**CITY OF BATAVIA**  
100 N. Island Ave., Batavia, IL 60510  
(630) 454-2000  
www.cityofbatavia.net

**PLAN COMMISSION  
AGENDA**

DATE: July 15, 2016  
TO: Plan Commission  
FROM: Drew Rackow AICP, Planner  
SUBJECT: Design Review: New Industrial Building 1200-1250 Douglas Road  
Morgan/Harbour Construction, Applicant

SITE PLAN

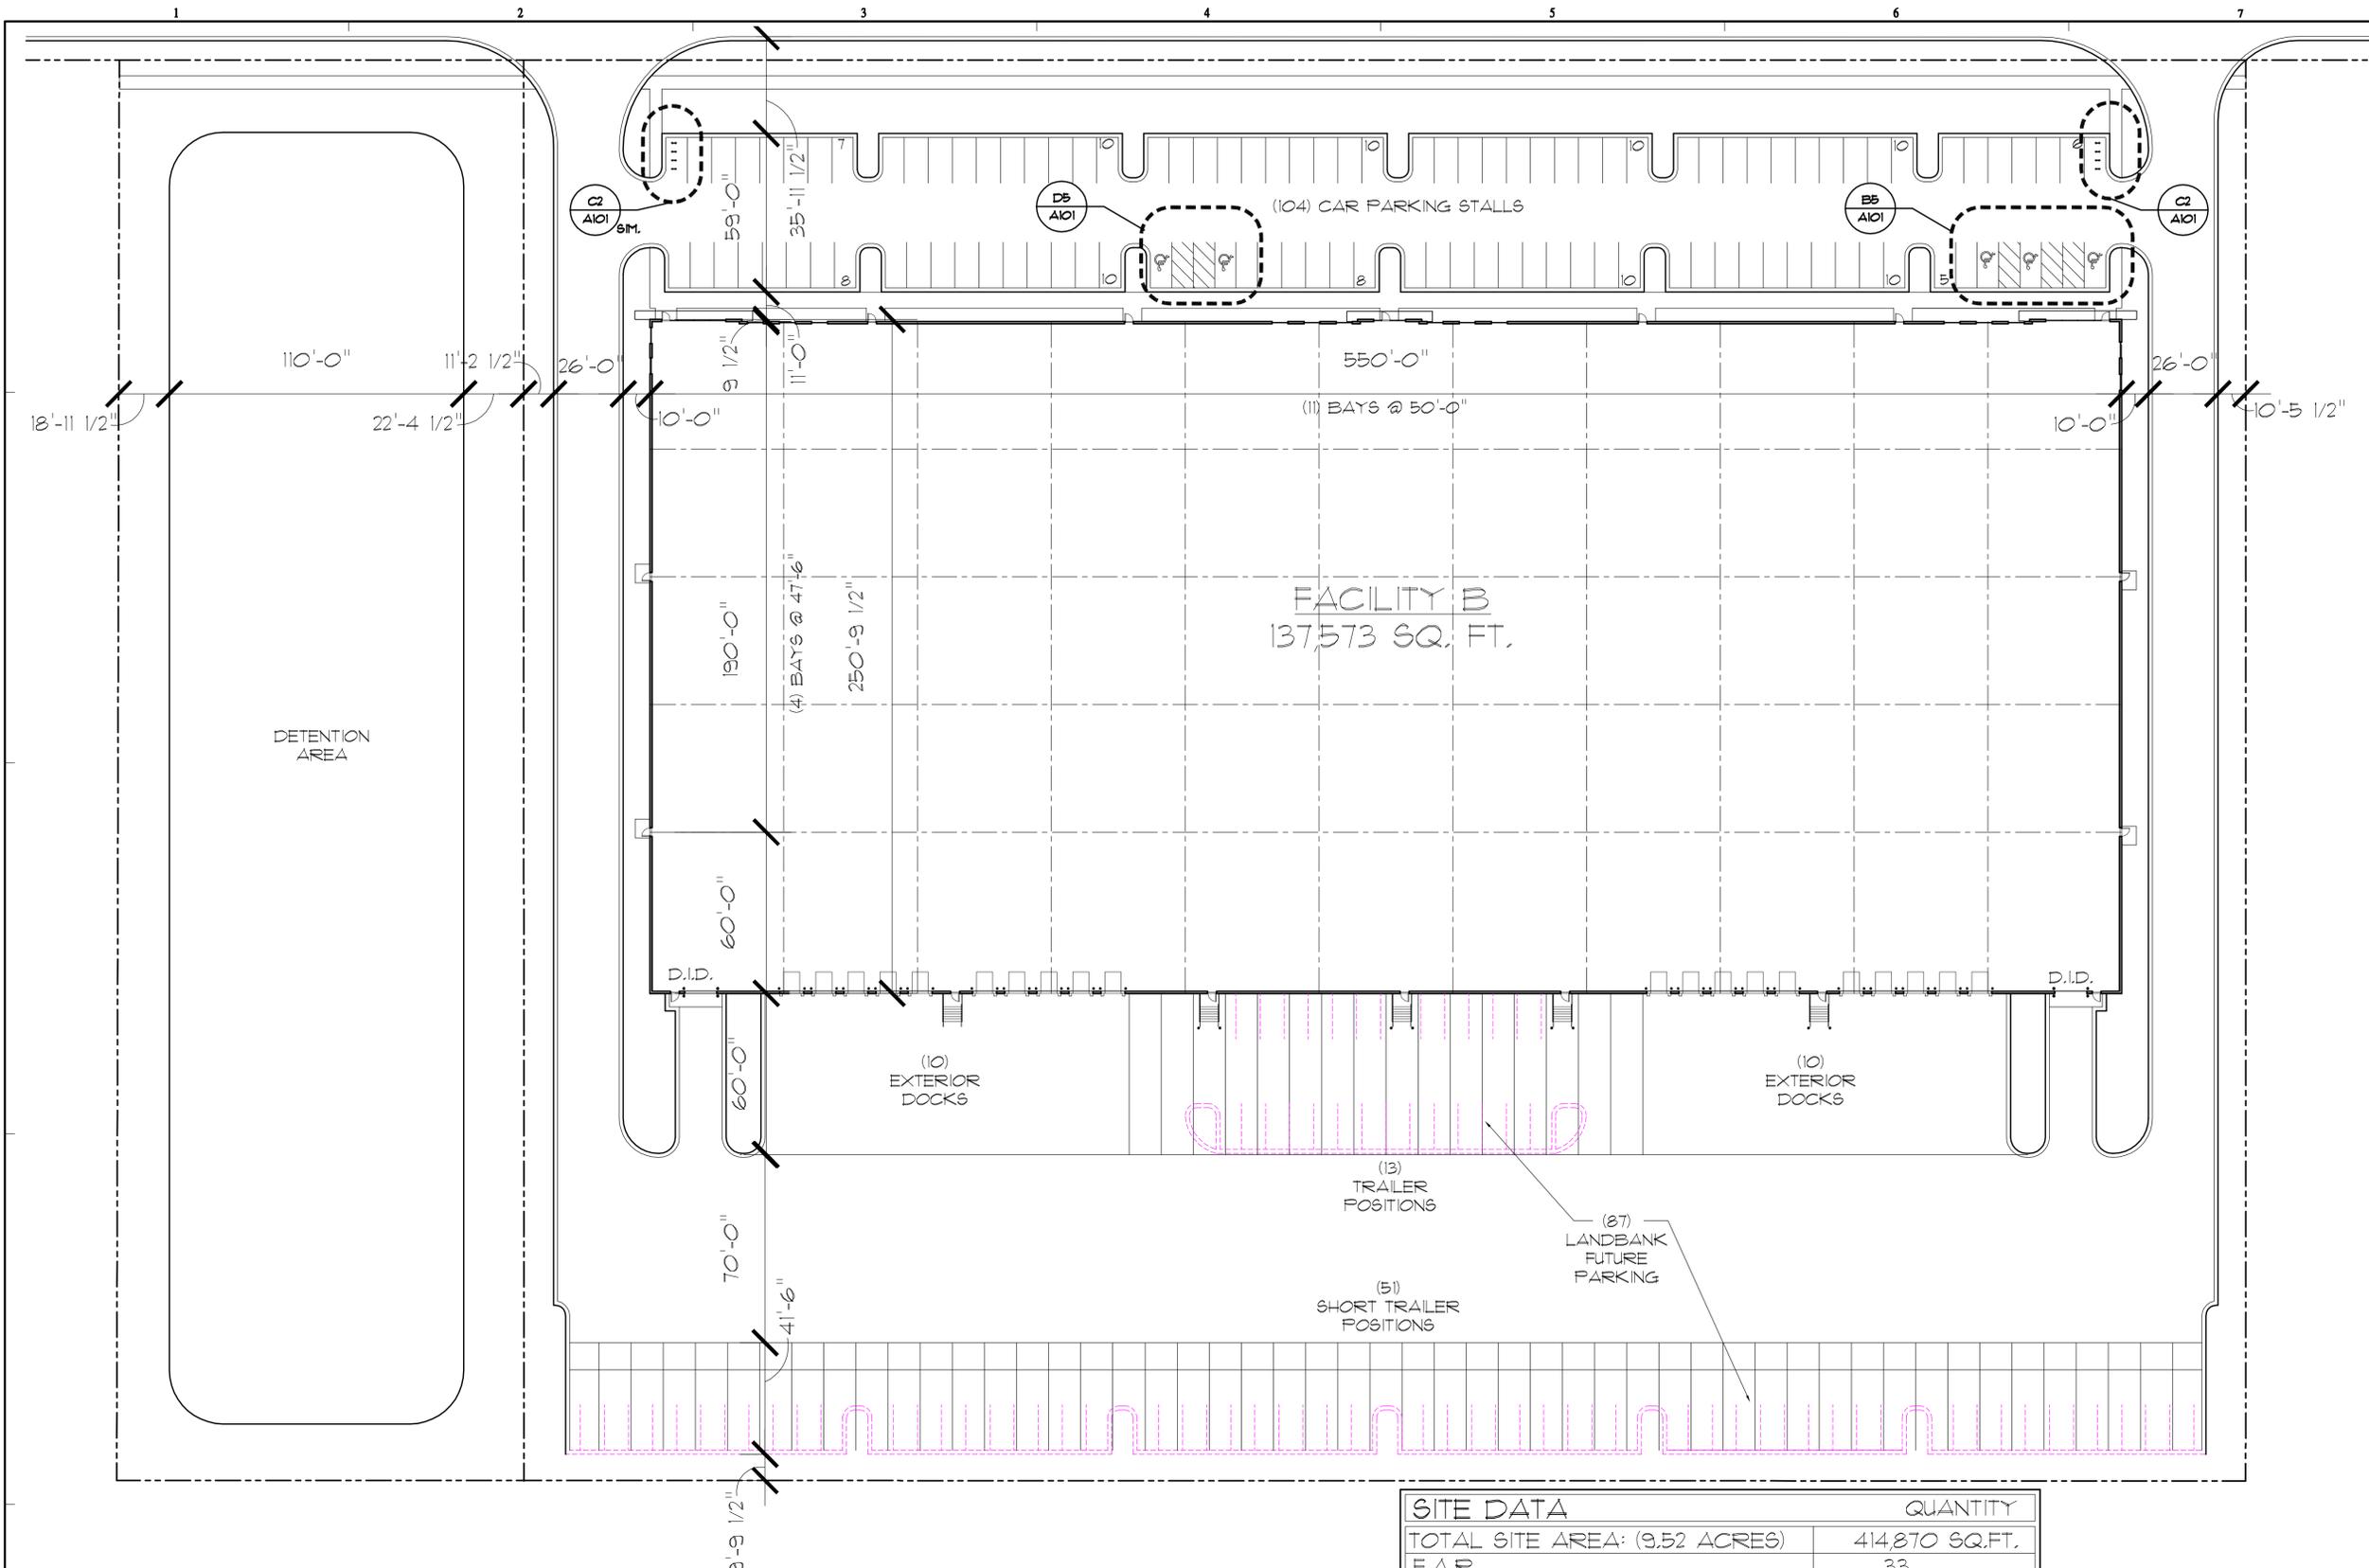
*Access:* Access would be provided by two access points from Douglas Road. Parking and docks would be separated. The proposed driveway would provide a fire lane around the building. Sidewalks are provided to the east and west of the building for pedestrian access. The sidewalk is not depicted consistently across all site plans. Staff will require these plans be consistent with permit submittal.

*Parking:* The site plan depicts 104 parking spaces, with 51 short trailer positions, 20 docks and 13 full trailer stalls. (73 trailer/truck spaces total). Warehousing requires 1 space per 1,000 square feet plus 1 space for every 250 square feet of office, assuming 5% of the space is used for office use 159 spaces are required. This results in a deficiency of 55 spaces. The applicant proposes to landbank up to 87 spaces within the trailer areas depicted on the site plan. The design of the southern landbank at the trailer storage area complies with the Zoning Code and would provide sufficient parking for warehousing, if required. The proposed landbank area near the building would need to include the required minimum of 4 feet separation from the building. The Zoning Code prohibits pull-through spaces, and the drive aisle will need to meet Code required widths. Staff believes both of these could be met with simple design alterations. The Plan Commission can require that these items all be addressed with staff approval of an Administrative Use Permit for the deferred (landbanked) parking. The depicted docks will meet the required loading spaces for the site, so these spaces are all beyond code requirements.

Bicycle parking is being provided in the vehicle parking lot near the parking lot entrances. Alternate locations could be considered, either reducing portions of the landscape area in front of, or along the sides of the building, freeing up these areas for additional vehicle parking, and allowing for greater flexibility for the use of the building (from a parking demand stand point). Staff would recommend the Commission consider these alternatives.

- b. Revisions of the Site Plan and other plans as necessary for permit submittal to:
    - i. depict the proposed transformer location per staff approval, with appropriate provision of easements.

- ii. to allow sufficient sanitary sewer and utility access for vehicles as determined by the Public Works Department, subject to Staff approval.
  - c. Revision of the Landscape Plan for permit submittal to depict the required Parkway trees, subject to approval by the Street Superintendent, as required by 7-2A of the Municipal Code.
